SIL 18-TR-21
November 12, 2021
Page 1 of 2

SUBJECT: Cancellation of 5000 and 6000 Series Standard Duty Retarder Rotor

MODELS AFFECTED: All 5000 and 6000 Series transmissions

Figure 1. Former and Current Retarder Rotor

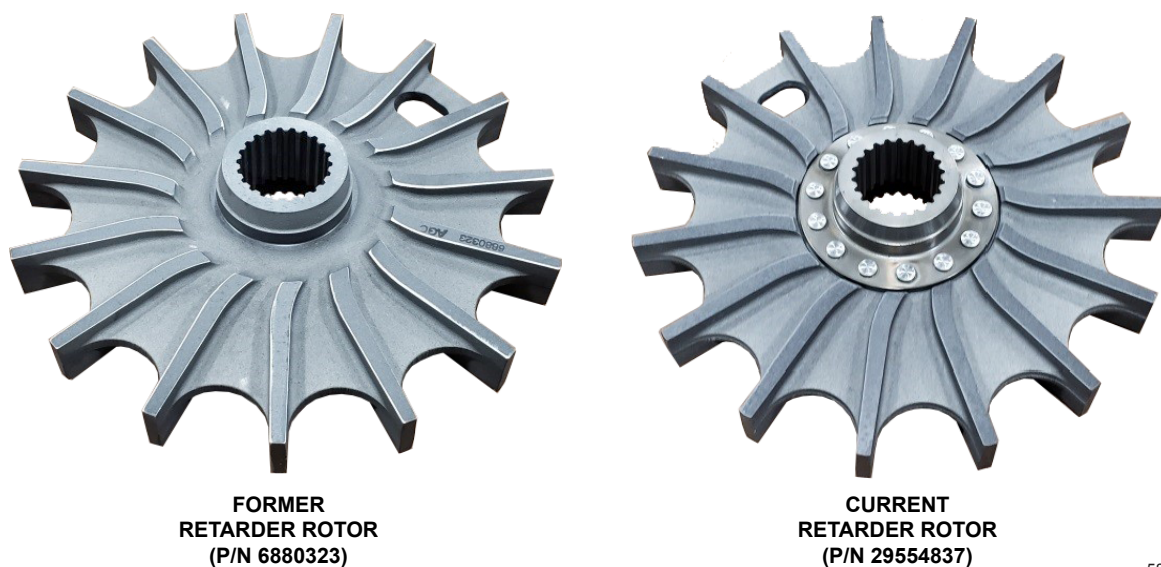
Effective August 1st, 2019, the heavy duty retarder rotor became a standard feature in all 5000 and 6000 Series transmissions equipped with a retarder. The heavy duty retarder rotor provides increased strength and durability. The heavy duty rotor features a 2-piece design utilizing a steel hub with a slip fit spline. Effective November 1st, 2021, the standard duty retarder rotor is completely cancelled and replaced by the heavy duty retarder rotor for all service needs.

The Heavy Duty Retarder Rotor P/N 29554837 is fully interchangeable backward. The Standard Duty Retarder Rotor P/N 6880323 will remain available until all stock has been exhausted. After stock of the standard duty retarder rotor has been exhausted, the heavy duty retarder rotor must be used.

NOTE: The Standard Duty Retarder Rotor P/N 6880323 should NOT be used to replace a Heavy Duty Retarder Rotor P/N 29554837. Doing so could cause premature failure of the retarder rotor.

The heavy duty retarder rotor features a slip fit spline and it is not required to heat the retarder rotor during installation. All other removal and installation procedures remain unchanged. Refer to SM7463EN for the complete service procedure for the retarder rotor.
